COIN COLLECTORS - PREPAY

COMMON BATTERY - CONNECTIONS

1.00 This section is reissued to add information on the KS-19147, List 1 cord insulator. ←

3.00 Circuit diagram for connection with 685B network-type subscriber set.

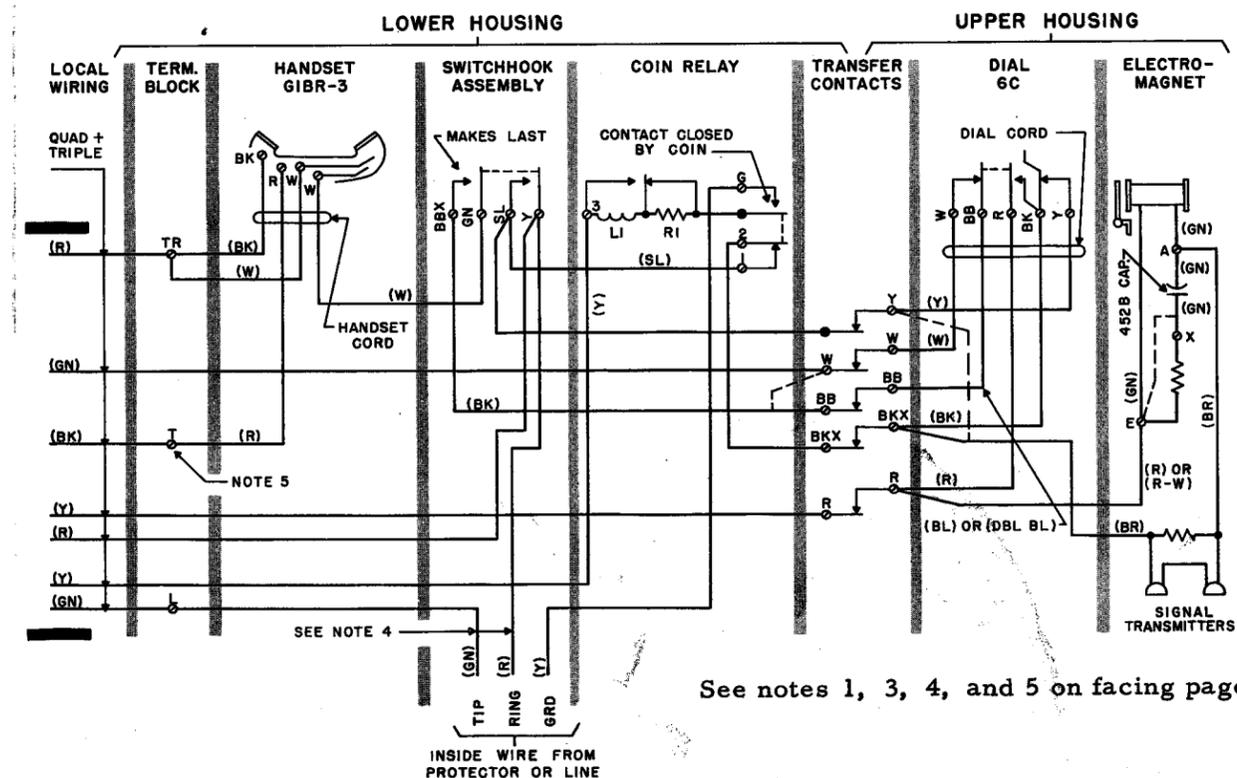
Note 5: New manufactured sets are wired as shown in 2.00. To rearrange for use with 685B subscriber set, disconnect yellow strap between T terminal and coin relay. Use KS-19147, List 1 cord insulator and turn back for future use.
